Planning Commission Regular Meeting

Tuesday, June 25, 2024

AGENDA ITEM:	Request by Maplewood Development for preliminary and final plat approval for Amber Fields 17th Addition to create 99 single-family lots.	AGENDA SECTION:	PUBLIC HEARINGS
PREPARED BY:	Alysha Grant, Community Development Technician	AGENDA NO.	6.a.
ATTACHMENTS:	Site Location, Existing Conditions, Site Plan, Phasing Plan, Grading & Drainage Plan, Erosion Control Plan, Utility Plan, Landscape Plan, Official Plat, Final Plat of Phase 1, Parks and Recreation Director's Memo Dated June 14, 2024, Engineer's Memo Dated June 20, 2024	APPROVED BY:	AK
RECOMMENDED ACTION: Motion to recommend the City Council approve the Preliminary and Final Plats for Amber Fields 17th Addition, subject to: 1. Execution of a subdivision agreement 2. Conformance with all requirements of the City Engineer as detailed in the attached memorandum dated June 20, 2024 3. No structures are allowed within any easement areas 4. Payment of \$39,270 as a landscape surety 5. Compliance with the conditions and standards within the Parks and Recreation Director's memorandum dated June 14, 2024. 6. Payment of trunk area charges in the amount of: 1. Sanitar

AMBER FIELDS - 17TH ADDITION
ROSEMOUNT, MINNESOTA
PRELIMINARY PLAT SUBMITTAL
SANITARY SEWER AND WATERMAIN PLAN OVERALL

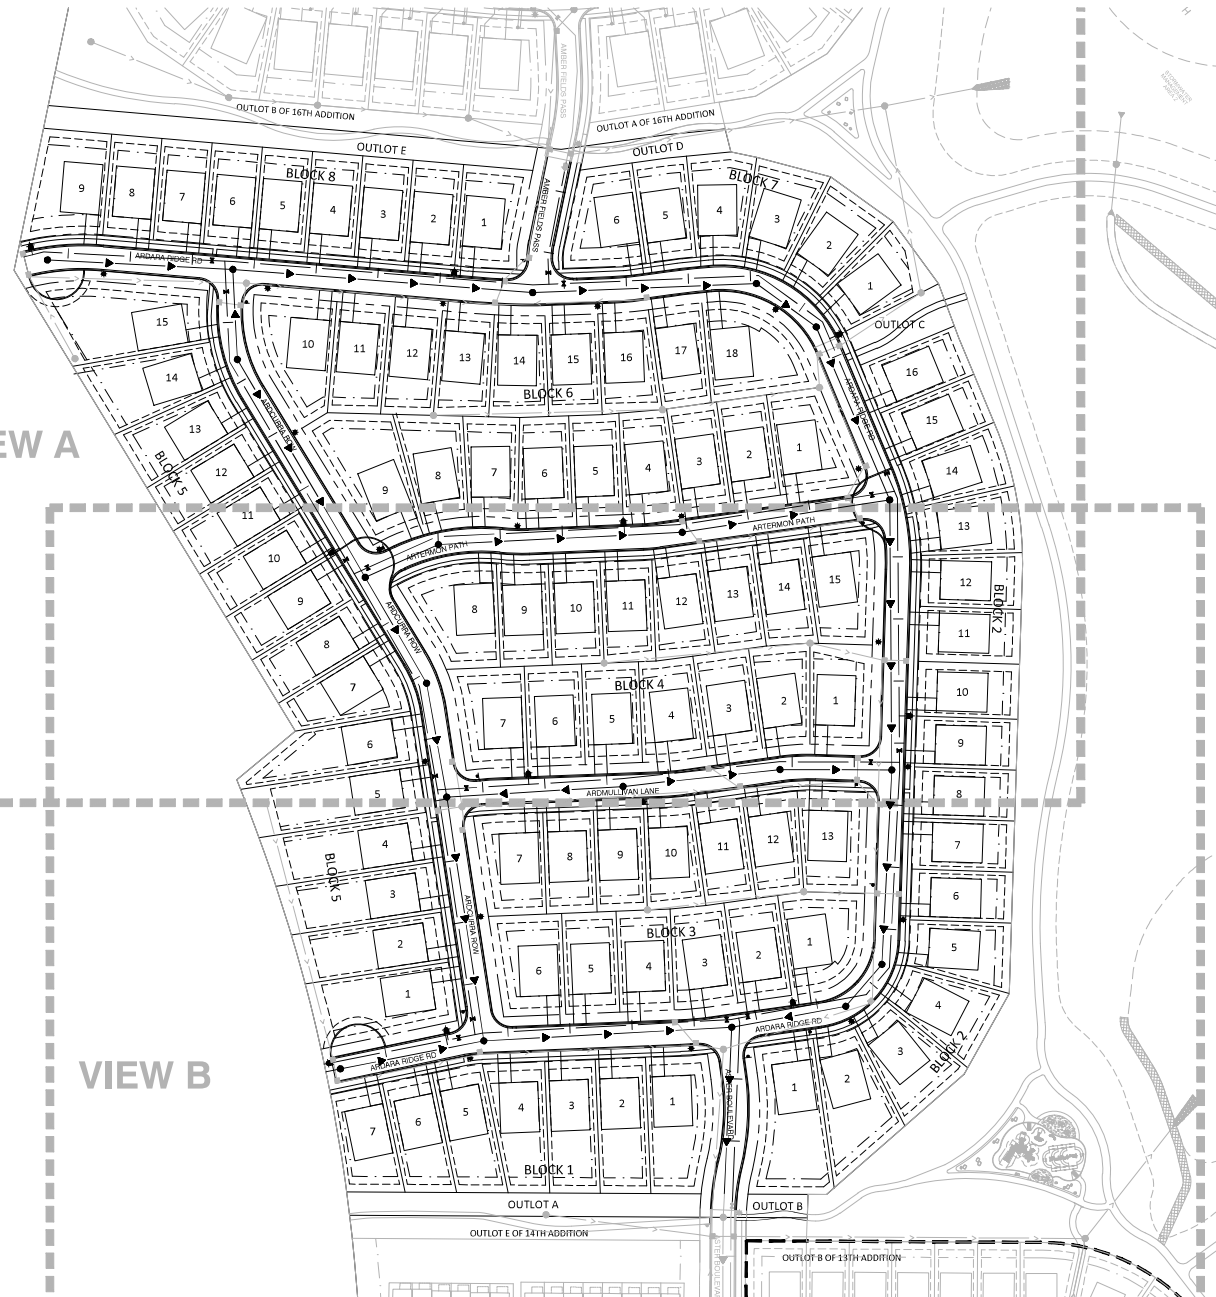
- c. CB 105 not shown in plan view of sheet 17.
- d. A sump should either be added to MH 100 or to both CBMH 101 and CBMH 106 prior to the connection into the existing stub.

AMBER FIELDS - 17TH ADDITION
PRELIMINARY PLAT SUBMITTAL
SANITARY SEWER AND WATERMAIN PLAN VIEW A
ROSEMOUNT, MINNESOTA

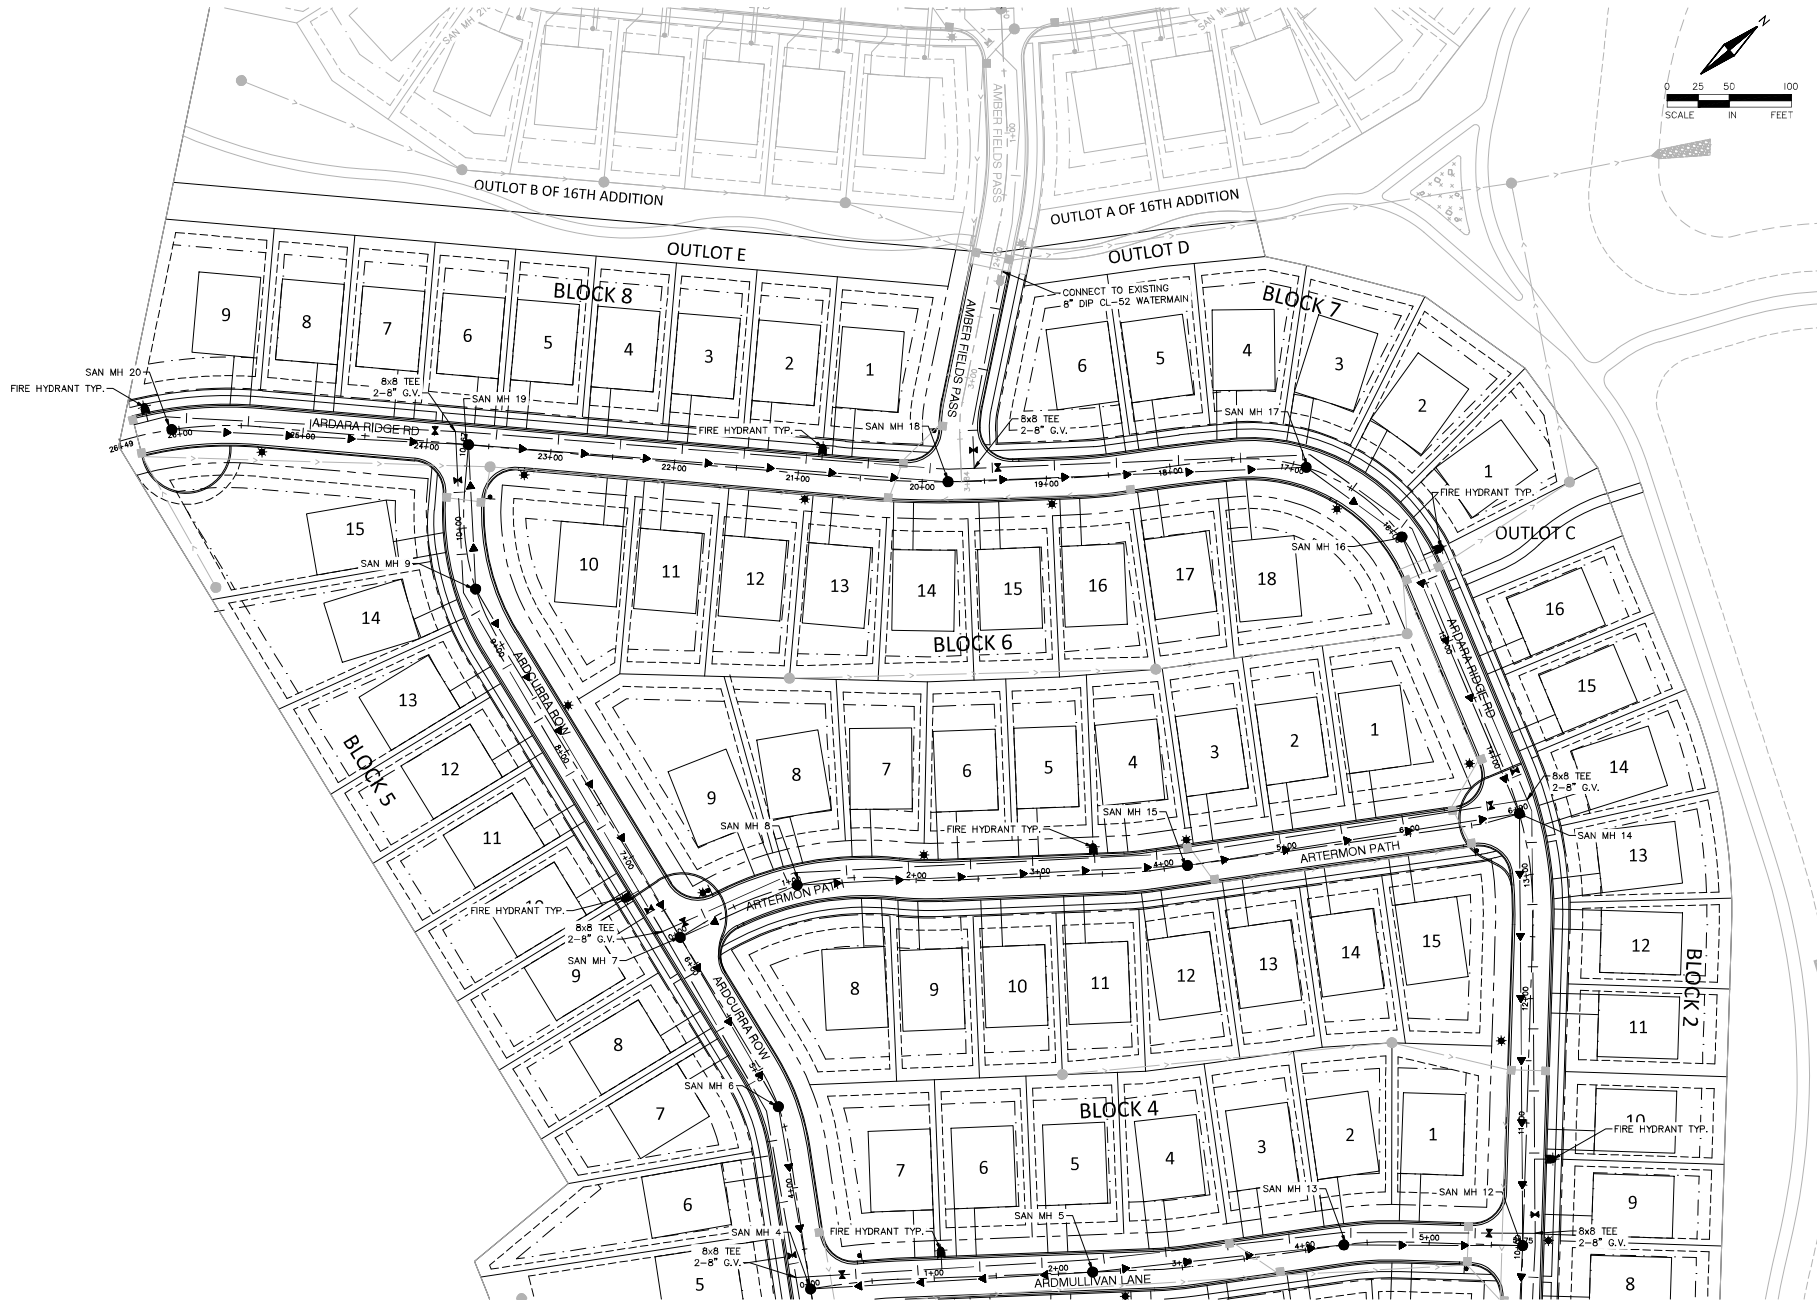
- g. Update the storm sewer profile shown on sheet 18 of the Final Plat Plans. Currently there is overlapping profiles shown.
- h. Confirm CB 118 is being placed at the low point. Unclear based on the profile and intersection details provided.

SHEET 20 of 26

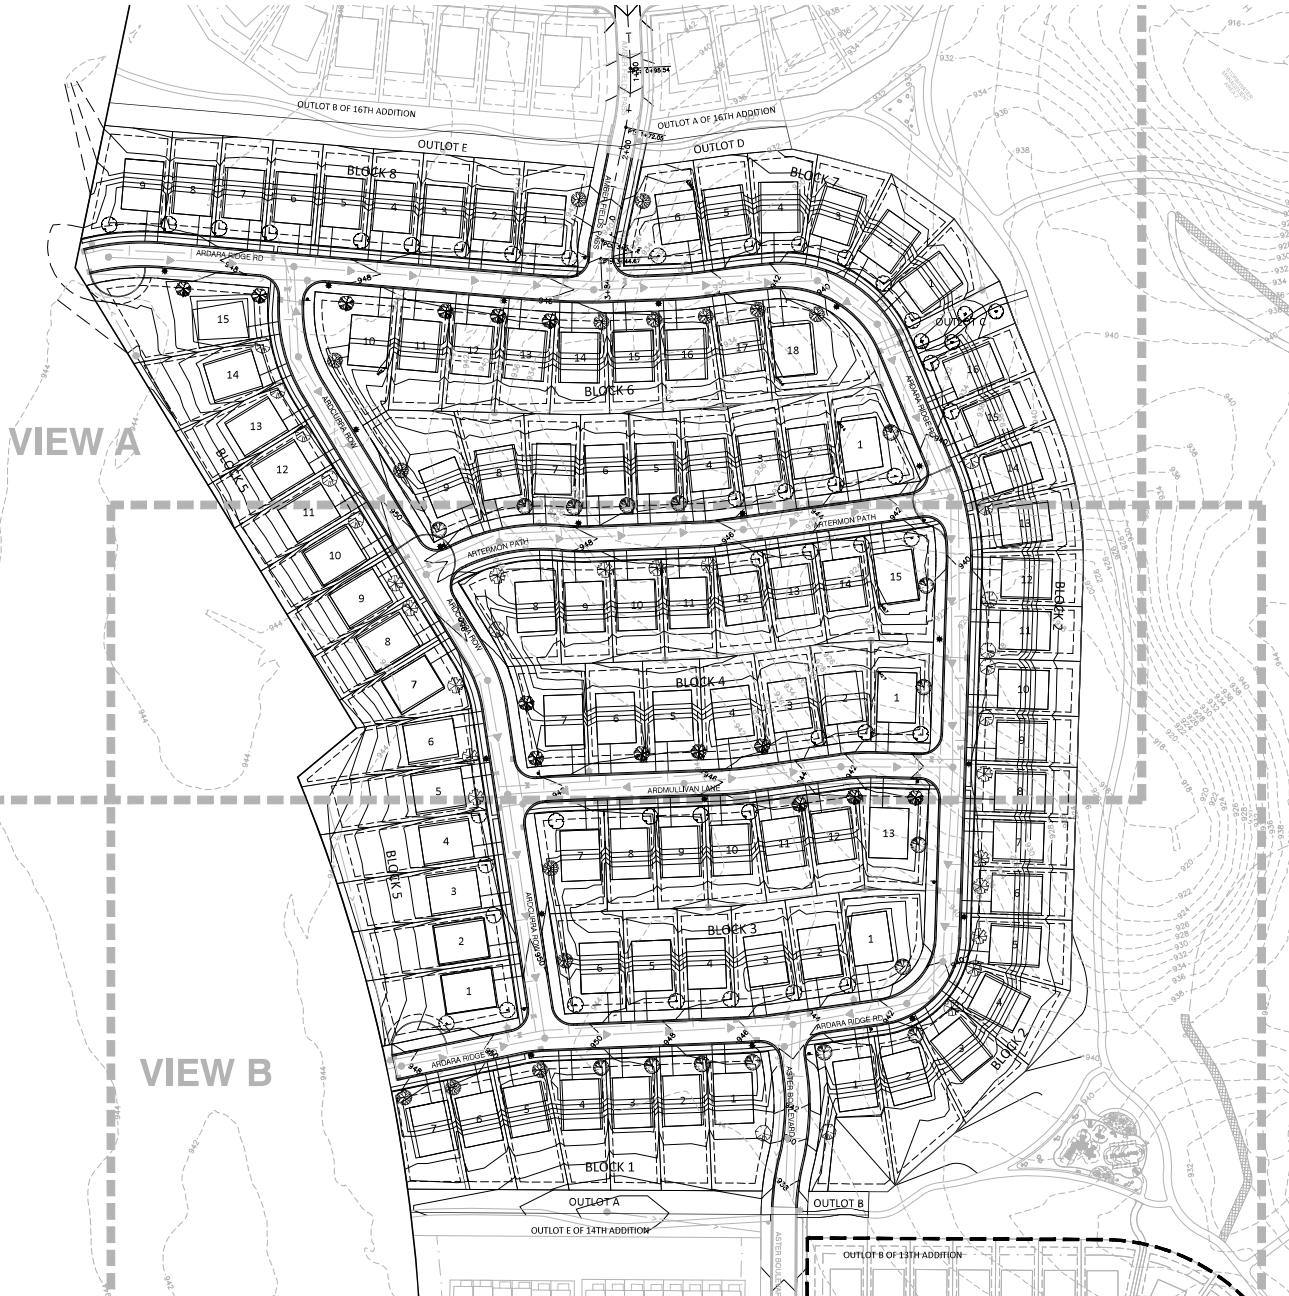
- i. The pipe between CB 118 and MH 116 is not showing up in the profile view on sheet 20.
